RE: Application #1-4728-05908/00001  
Village of Ocean Beach Walkways & Retaining Wall Construction  
Cottage Walk to Surf View Walk | Fire Island

I am writing in response to your Notice of Incomplete Application dated 10/29/2020. Please find enclosed four (4) sets of Site Plans for the Village of Ocean Beach Walkways & Retaining Wall Construction project, revised as follows:

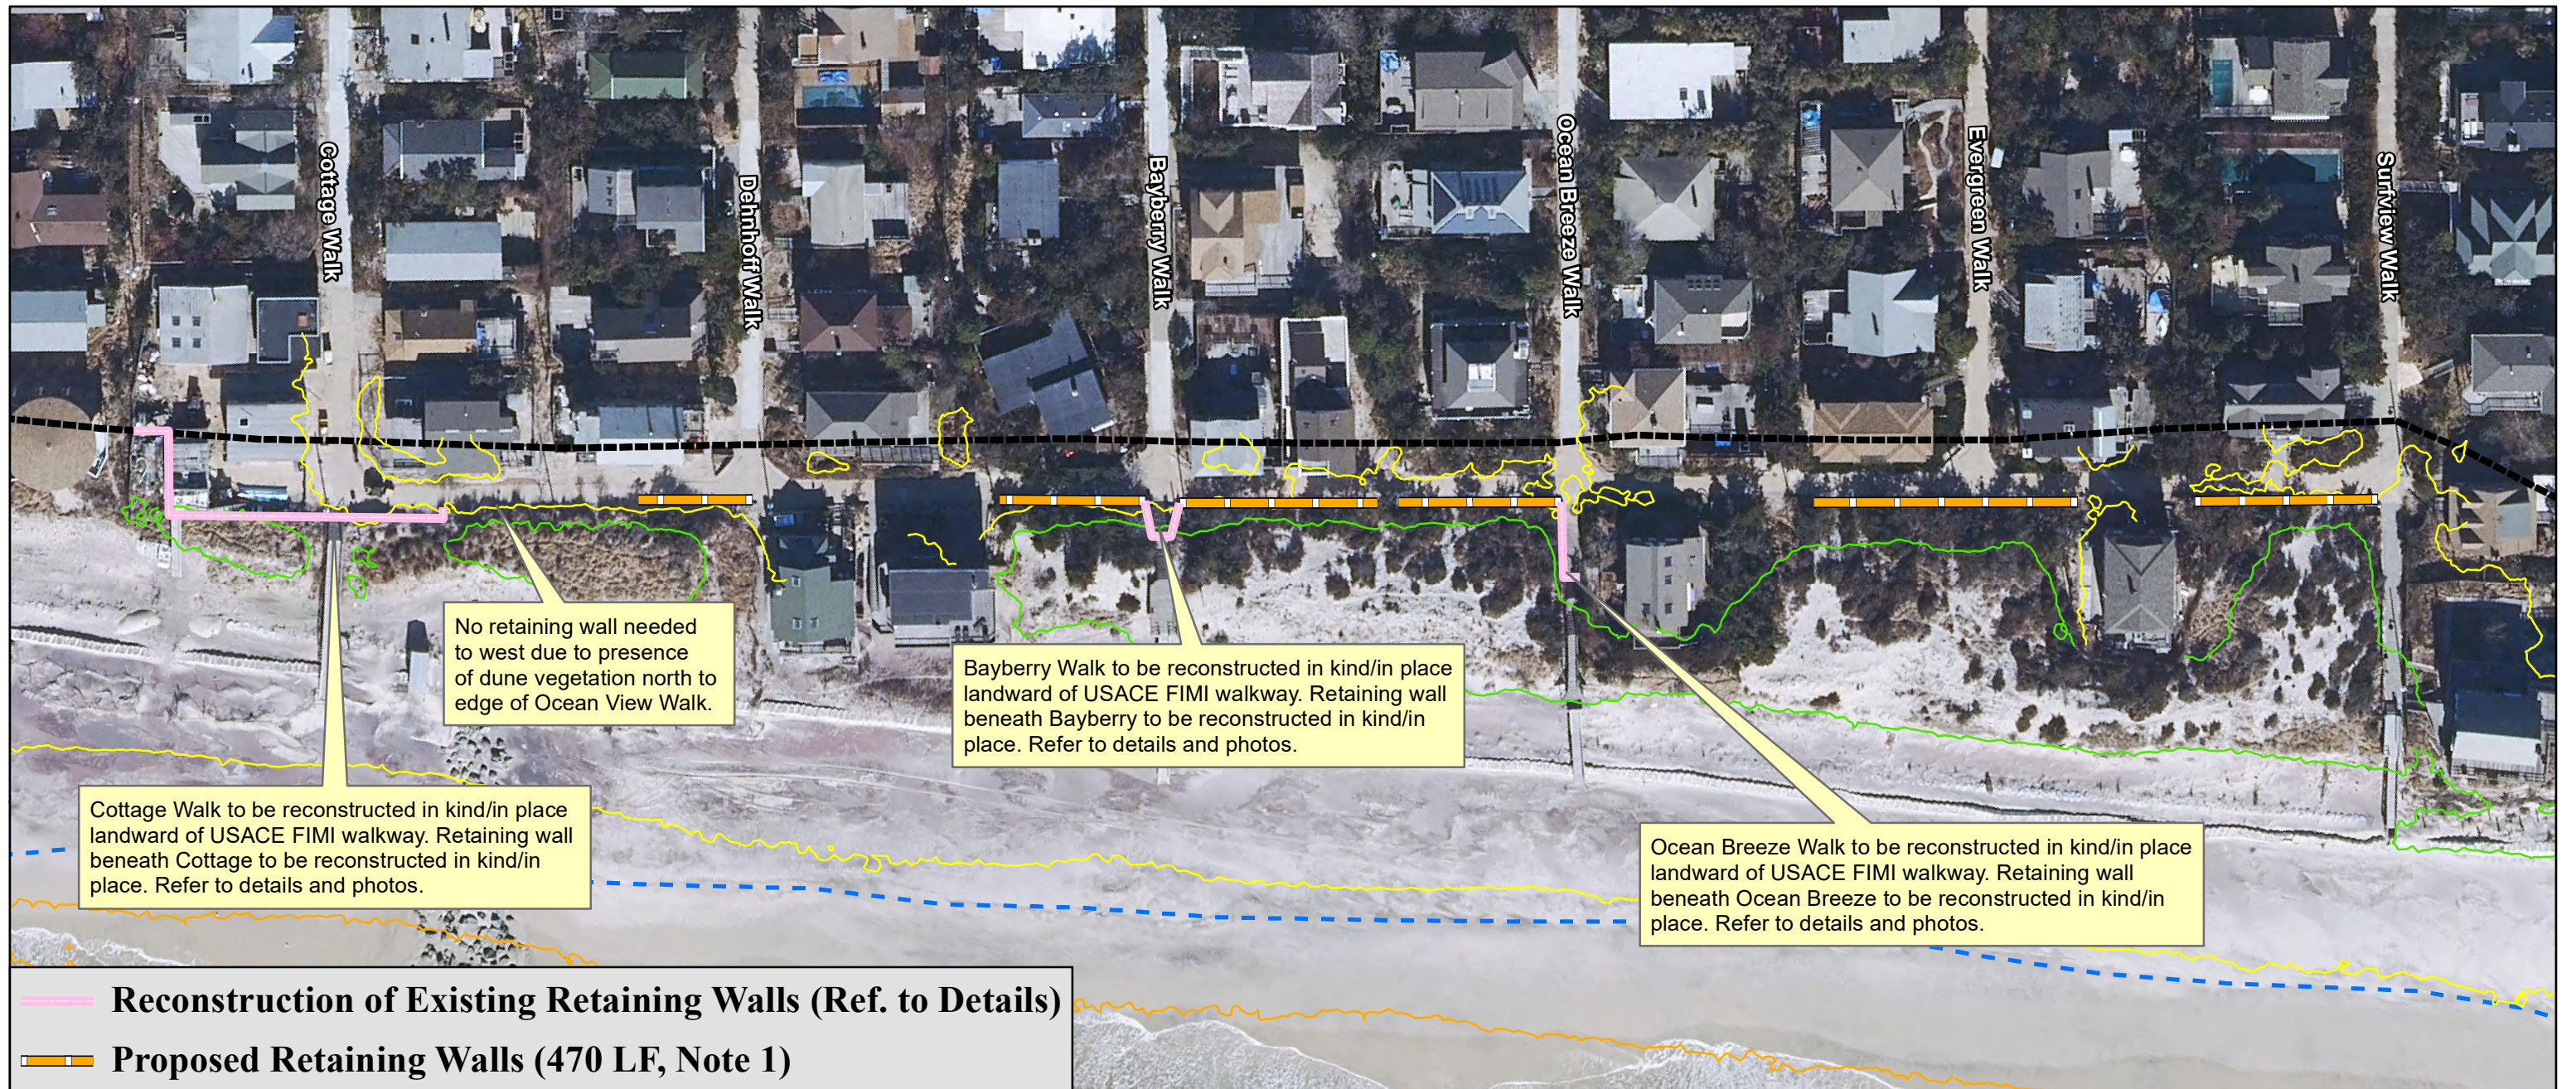
- Site Layout Plan has been revised to depict (1) AHW and (2) elevation contours based on NOAA 2020 LIDAR data for New York. Please note that all activities are proposed landward of both the 10 foot and 15 foot NAVD88 elevation contours based on this LIDAR data. As stated in the original application submission, activities are proposed landward of the FIMI dune restoration project, and landward of the natural vegetated dune.

In addition, please refer to the legend present on the Site Plan for a description of each proposed activity. The easternmost structure is a section of proposed retaining wall, as noted in the legend.

# Cottage Walk Overpass

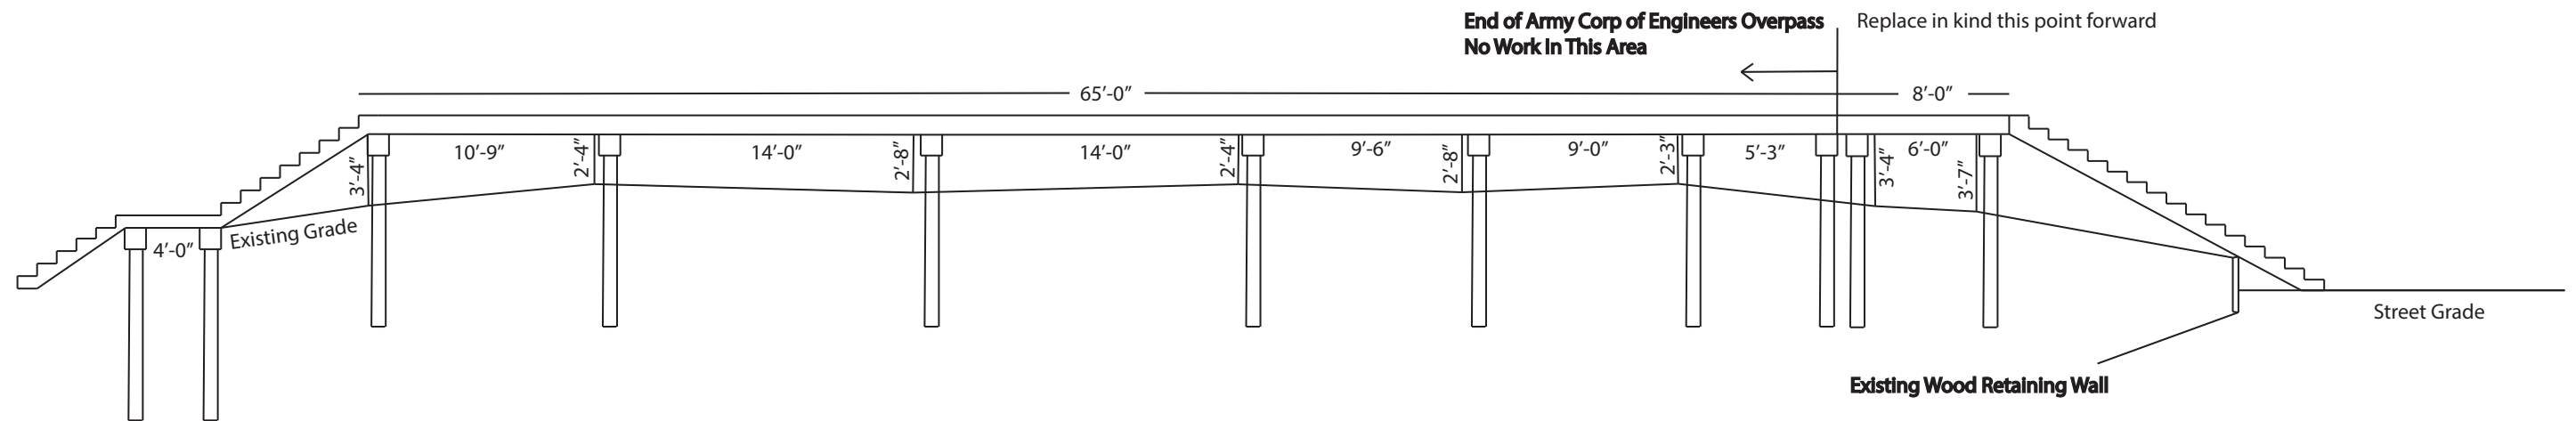
- Site Details – Legible copies of all plans and details are enclosed. Misspellings have been corrected.
- Section Views – Cross sections of the walkways at Cottage, Bayberry, and Ocean Breeze are now provided. The retaining wall section previously submitted is unchanged, additional copies are enclosed for reference.
